SERVICE BULLETIN NO: 53-002

FUSELAGE STOP NUTS - REPLACEMENT

PILATUS
PC-6
SERVICE BULLETIN

Tail Landing Gear - Nut Replacement
Figure 1

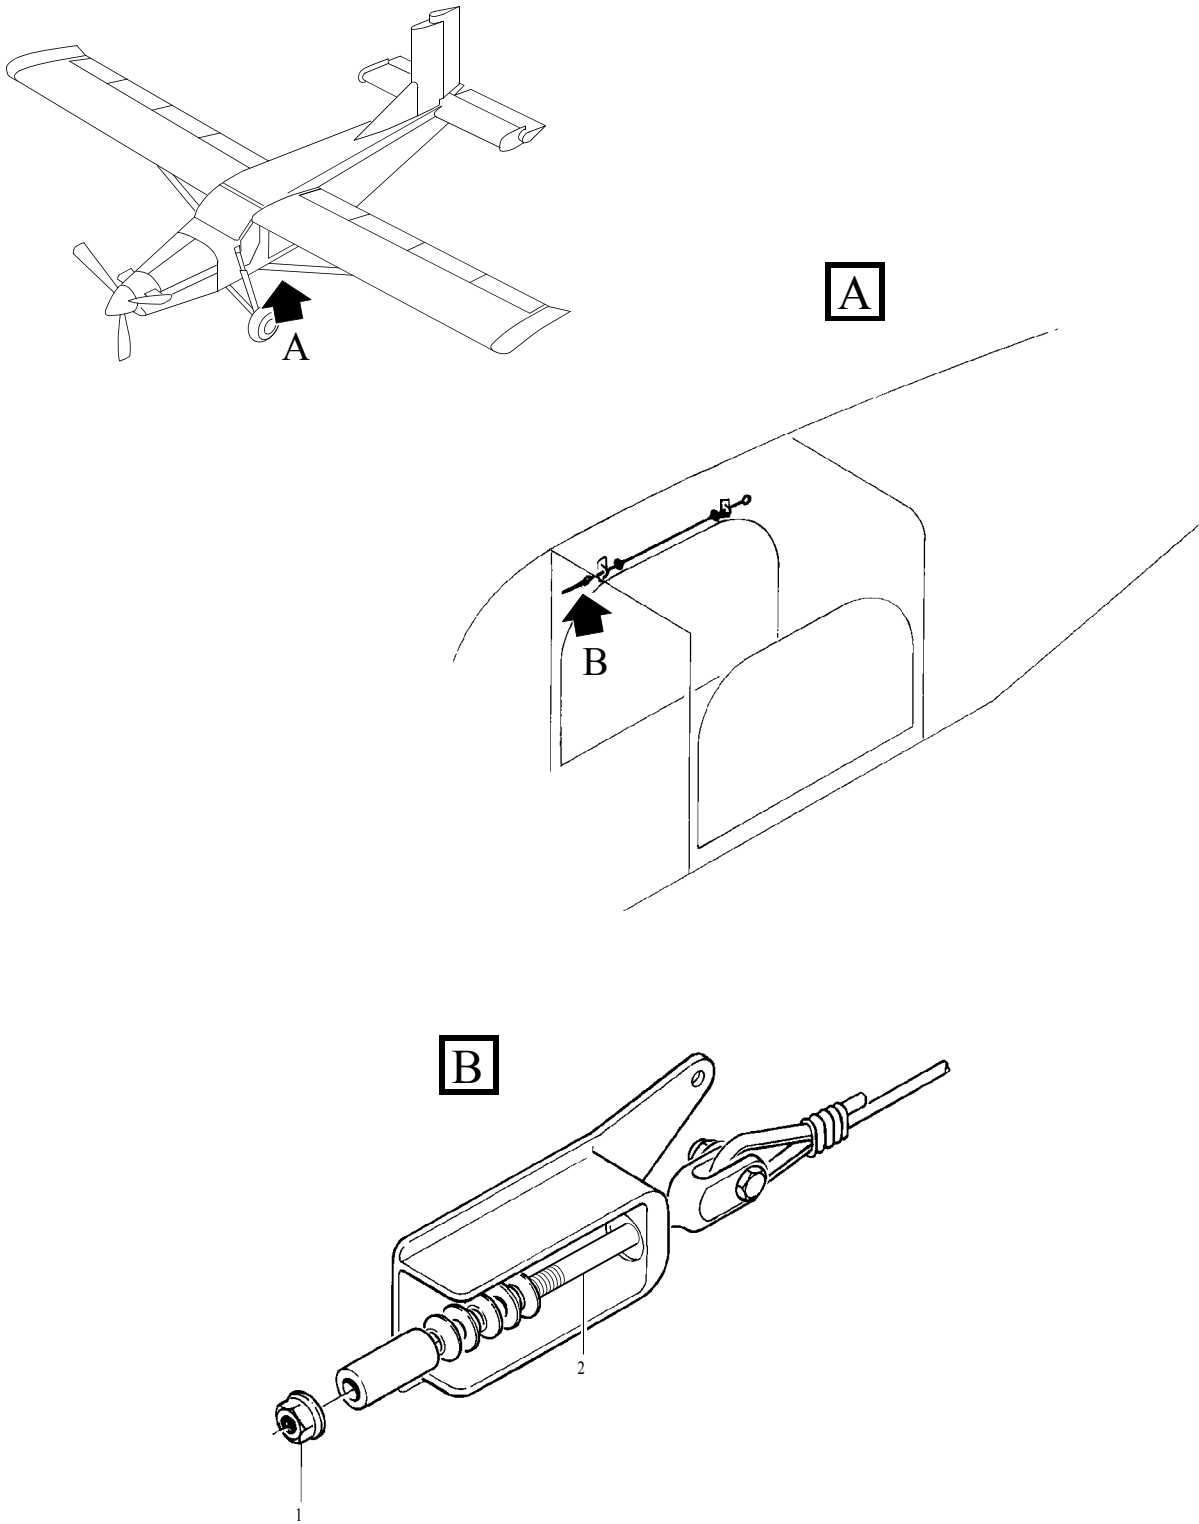
B. Nut Replacement - Tail Landing Gear (Ref. Fig. 1)

- (1) Do an inspection to identify the nut (1). You must replace nuts (938.07.65.105) with nuts (938.07.31.124).
- (2) Replace the left nut (Ref. IPC, 32-71-01, Fig. 01). This step is only necessary if you found nuts (938.07.65.105) in Step (1).
 - (a) Lift the rear of the aircraft and put the tail stand in position (Ref. AMM, 07-10-00, Page Block 201).
 - (b) Disassemble and remove the nut (1) washer (2) and the bolt (3). Discard the nut.
 - (c) Install the bolt (3), washer (2) and new nut (1).
- (3) Do Step (2), (b) and (c) again to replace the right nut.
- (4) Remove the tail stand (Ref. AMM, 07-10-00, Page Block 201).

Parachute Cable Assembly - Nut Replacement
Figure 2

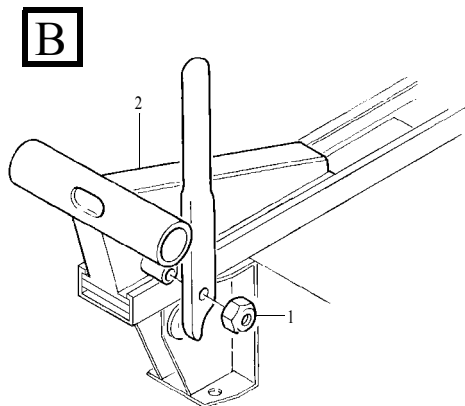
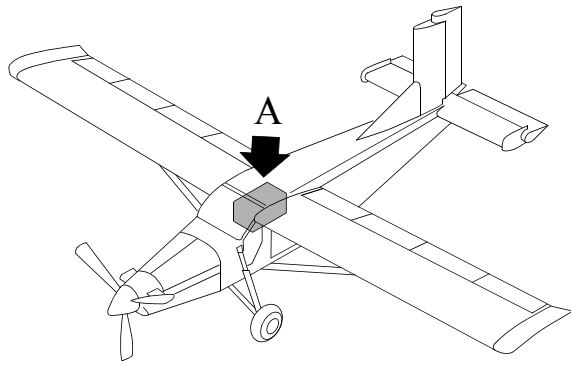
C. Nut Replacement - Parachute Cable Installation (if Installed) (Ref. Fig. 2)

- (1) In the cabin, do an inspection to identify the nut (1). You must replace a nut (938.07.65.105) with a nut (938.07.31.108) or (938.07.34.104).
- (2) Replace the nut (Ref. IPC, 25-25-02, Fig. 01). This step is only necessary if you found a nut (938.07.65.105) in Step (1).
 - (a) Remove the nut (1) from the clevis (2). Discard the nut.
 - (b) Install the new nut (1) on the clevis (2).

Water Tank Assembly - Nut Replacement
Figure 3

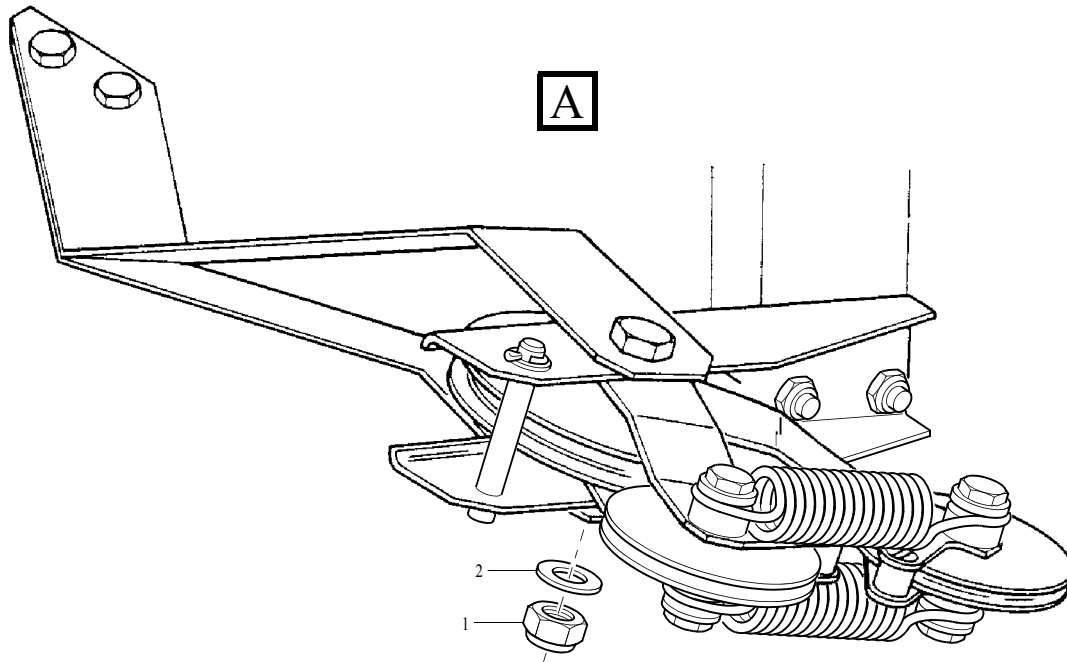
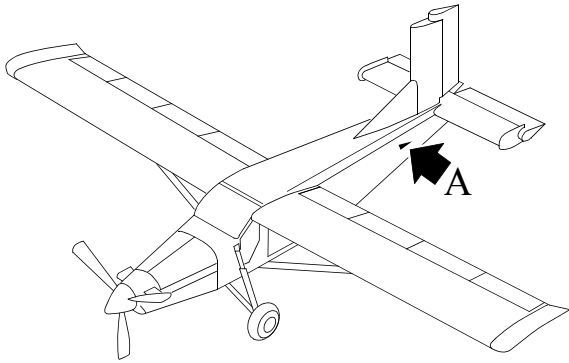
D. Nut Replacement - Water Tank Assembly (if Installed) (Ref. Fig. 3)

- (1) In the cabin, do an inspection to identify the nut (1). You must replace a nut (938.07.65.105) with a nut (938.07.31.124).
- (2) Replace the nut (Ref. IPC, 25-28-01, Fig. 01). This step is only necessary if you found a nut (938.07.65.105) in Step (1).
 - (a) Remove the nut (1) from the sliding carriage and lever assembly (2). Discard the nut.
 - (b) Install the new nut (1) on the sliding carriage and lever assembly (2).

A. Nut Replacement - Water Tank Assembly (Ref. Fig. 3)

- (1) Do an inspection to identify the nut (1). You must replace a nut (938.07.65.105) with a nut (938.07.31.124).
- (2) Replace the nut (Ref. IPC, 25-28-01, Fig. 01). This step is only necessary if you found a nut (938.07.65.105) in Step (1)
 - (a) Remove the nut (1) from the sliding carriage and lever assembly (2). Discard the nut.
 - (b) Install the new nut (1) on the sliding carriage and lever assembly (2).

Cable Tensioner Assembly - Nut Replacement
Figure 4

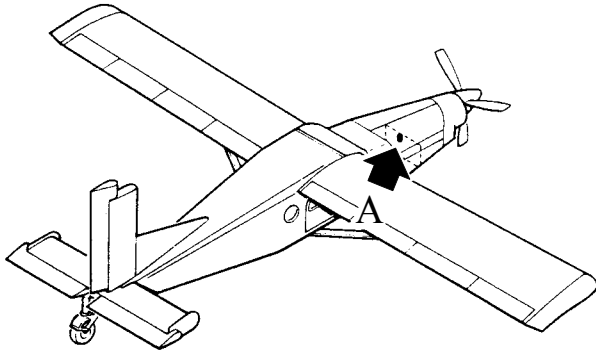
E. Nut Replacement - Cable Tensioner Assembly (Ref. Fig. 4)

- (1) In the rear fuselage, do an inspection to identify the nut (1). You must replace a nut (938.07.65.105) with a nut (938.07.31.108).
- (2) Replace the nut (Ref. IPC, 27-45-11, Fig. 01). This step is only necessary if you found a nut (938.07.65.105) in Step (1).
 - (a) Remove the nut (1) and washer (2) from the bolt (3). Do not remove the bolt when you do this. Discard the nut.
 - (b) Install the washer (2) and new nut (1) on the bolt (3).

Fuel Filter Assembly - Nut Replacement
Figure 5

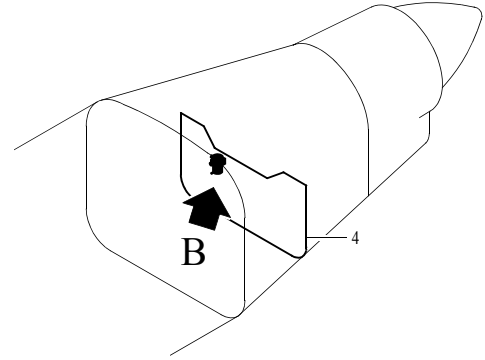
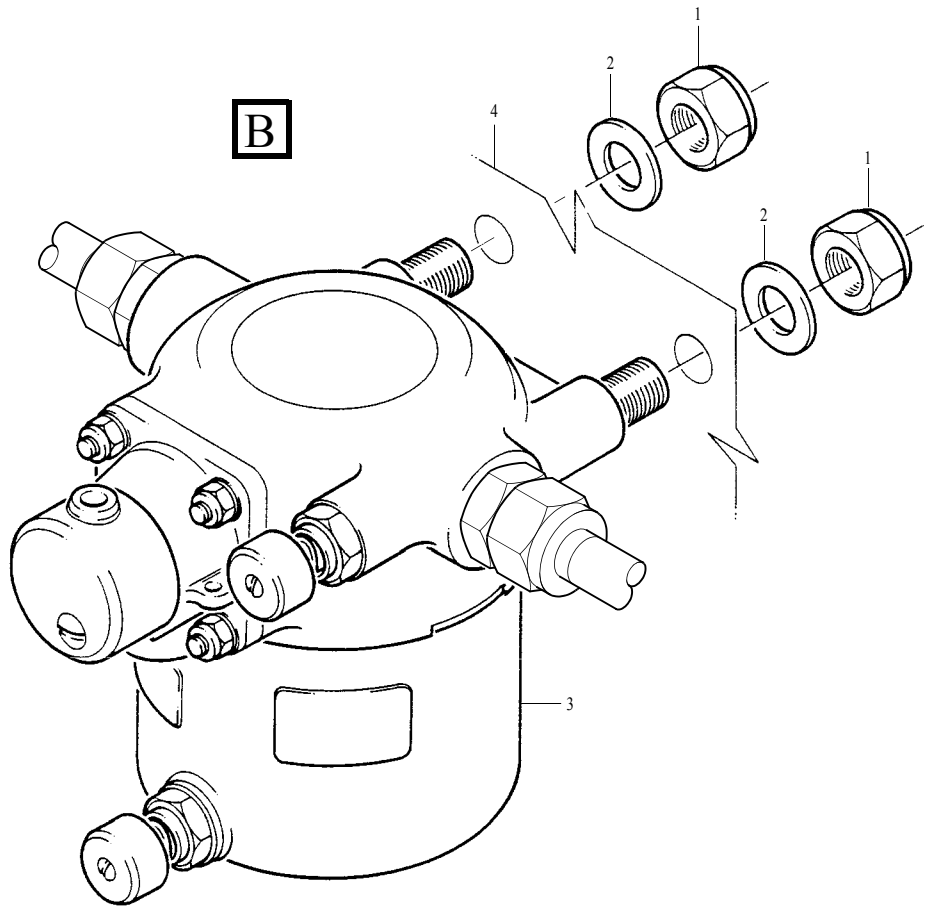
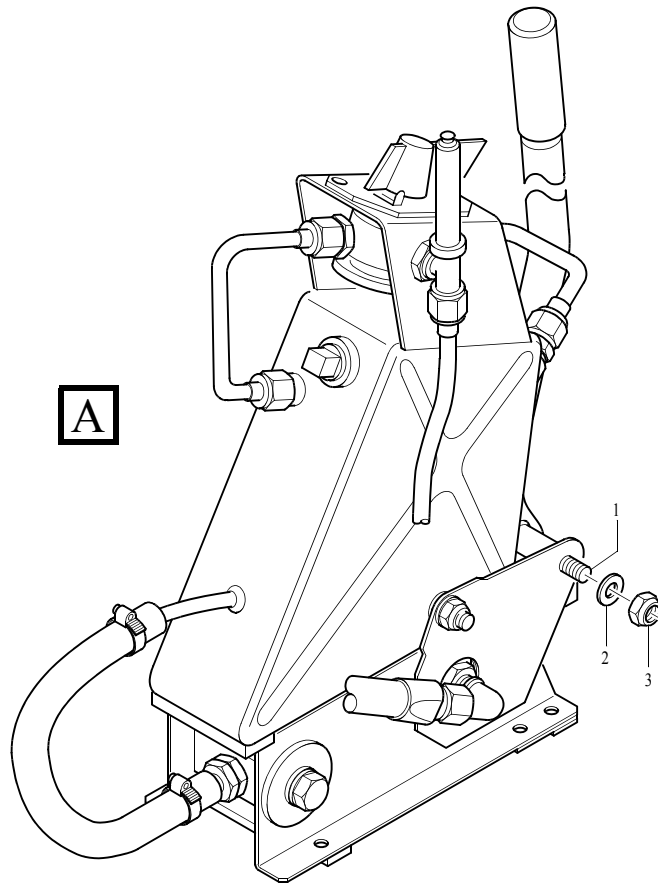
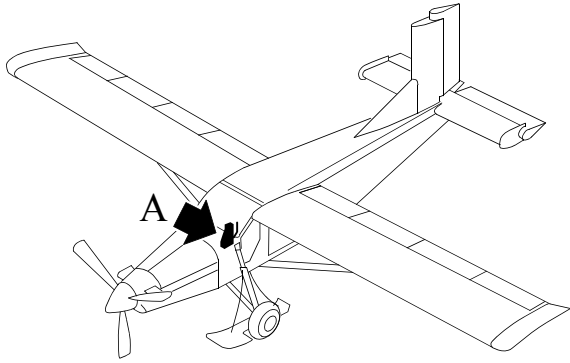
F. Nut Replacement - Fuel Filter Assembly (Ref. Fig. 5)

- (1) In the engine compartment, do an inspection to identify the nuts (1). You must replace nuts (938.07.65.105) with nuts (938.07.31.108) or (938.07.34.104).
- (2) Replace the nuts (Ref. IPC, 28-21-01, Fig 01). This step is only necessary if you found nuts (938.07.65.105) in Step (1).
 - (a) In the nose section forward of the auxiliary bulkhead (4), remove the nuts (1) and washers (2) from the studs of the fuel filter assembly (3). Discard the nuts.
 - (b) Install the washers (2) and new nuts (1) on the studs of the fuel filter assembly (3).

Hydraulic Pump Assembly - Nut Replacement
Figure 6

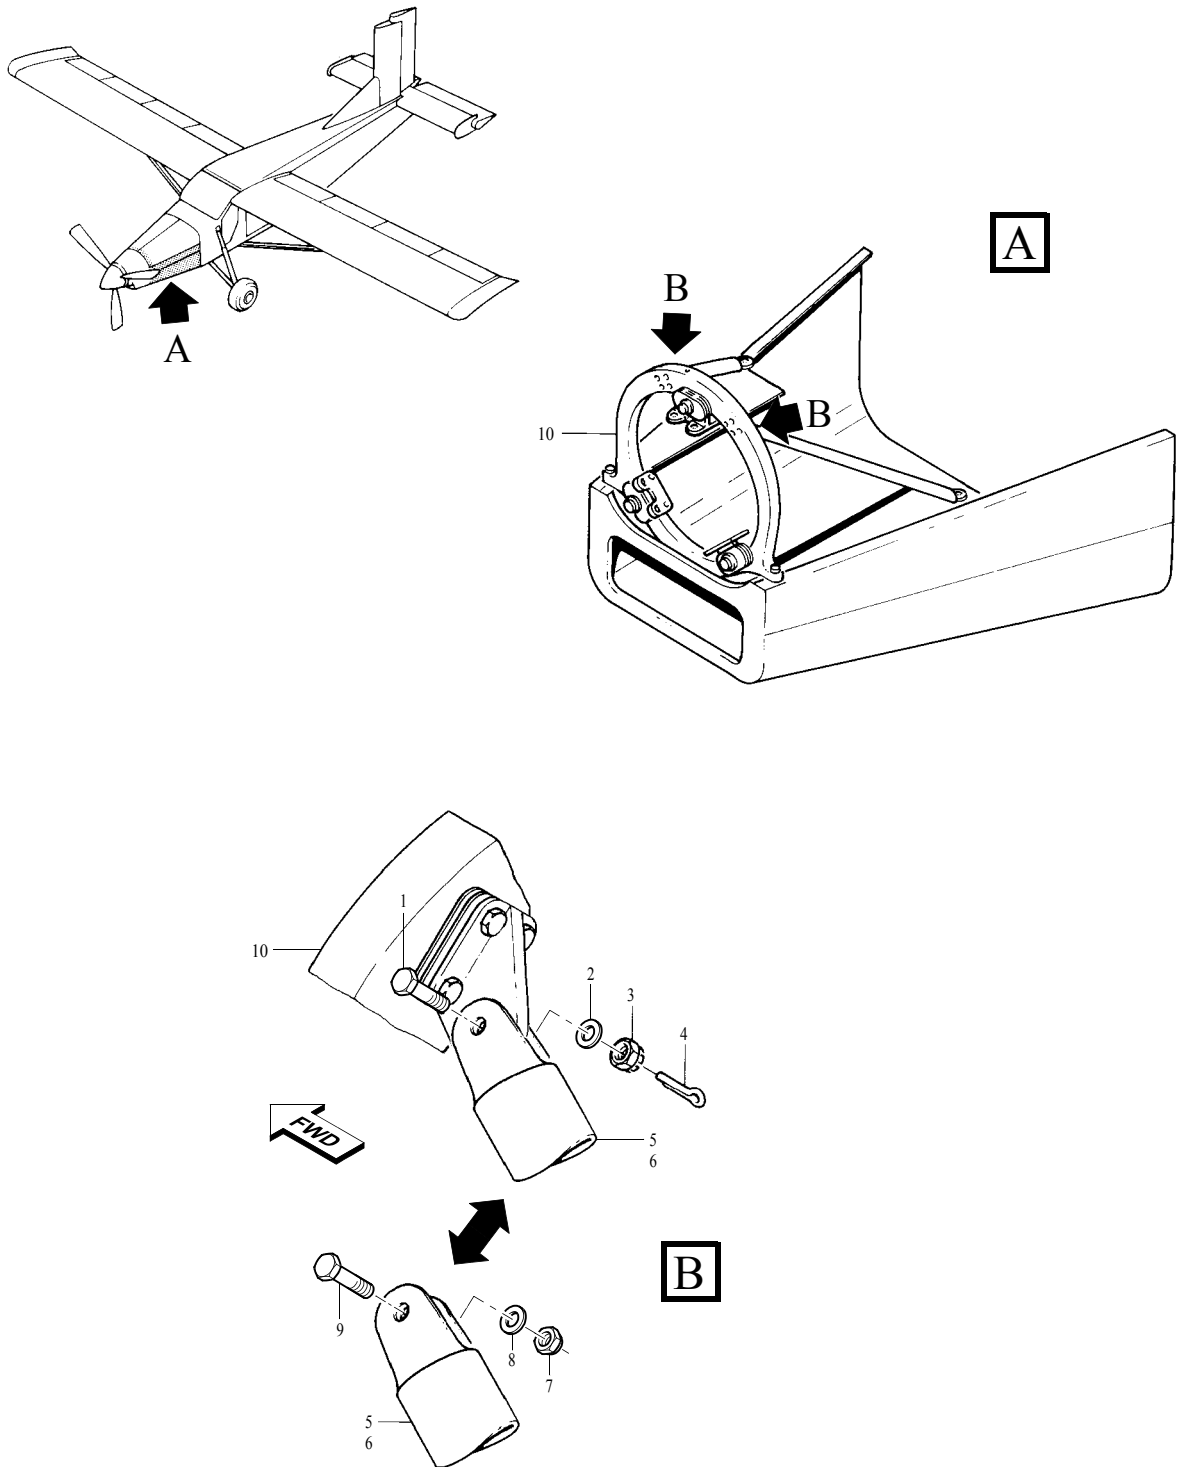
G. Nut Replacement - Hydraulic Pump Assembly (if Installed) (Ref. Fig. 6)

- (1) Do an inspection to identify the nuts (3). You must replace nuts (938.07.65.105) with nuts (938.07.31.124).
- (2) Replace the nuts (Ref. IPC, 32-77-01, Fig 01) This step is only necessary if you found nuts (938.07.65.105) in Step (1).
 - (a) Remove the nuts (3) and washers (2) from the screws (1). Discard the nuts.
 - (b) Install the washers (2) and new nuts (3) on the screws (1).

B. Nut Replacement - Hydraulic Pump Assembly (if Installed) (Ref. Fig. 6)

- (1) Do an inspection to identify the nuts (3). You must replace nuts (938.07.65.105) with nuts (938.07.31.124).
- (2) Replace the nuts (Ref. IPC, 32-77-01, Fig 01) This step is only necessary if you found nuts (938.07.65.105) in Step (1).
 - (a) Remove the nuts (3) and washers (2) from the screws (1). Discard the nuts.
 - (b) Install the washers (2) and new nuts (3) on the screws (1).
